Operator Quality Production Corp.  
 Well Maljamar 'A' State #2  
 Unit A Section 36 Township 17 Range 31  
 API# 30-015-10474

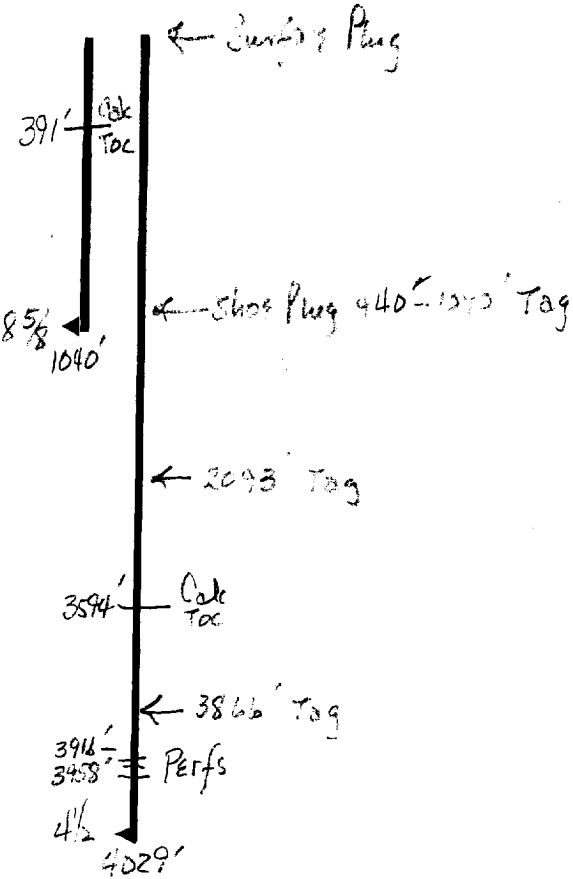
- \* Contact OCD 24 hrs. prior to any work done.
- \* Salt gel mud consisting of 10# brine with 25# of gel per barrel must be placed between each plug.
- \* Install dry hole marker as per Rule 202.B.2
- \* Plugs are to be set from point indicated up.
- \* Plugs must not be less than 100' or 25 Sacks of cement, whichever is greater, unless specifically indicated.
- \* Shoe and stub plugs will be 50' above and below shoe or stub and tagged.
- \* Surface plug will be from 0' - 60'
- \* Where plugs are required, cement must be placed inside and outside of all casing string(s) in the correct footage or sacks required, if no cement exists.
- \* Plugs to be tagged will be indicated.
